PRODUCT BULLETIN – PB-162 Inverter Replacement – EH030, EH040

Summary

14998918 Kit

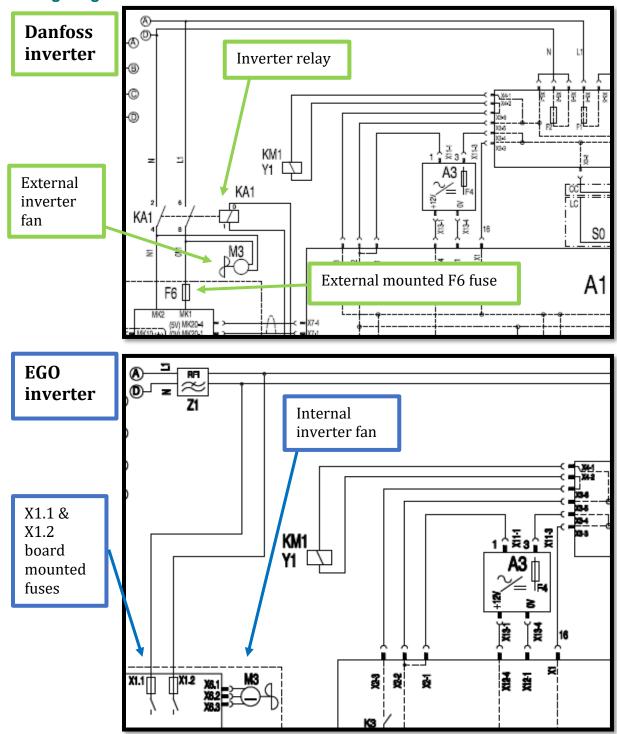
The EGO inverter kit will include the following parts:

- Inverter kit assembly
- Installation instructions
- Jump drive that will include
 - GMP Tool
 - Instructions on how to load the GMP Tool to your computer
 - o Instructions on how to load new software to the microprocessor
 - o Logi/ Vended software version 61 or greater
 - o Inteli software version 47 or greater
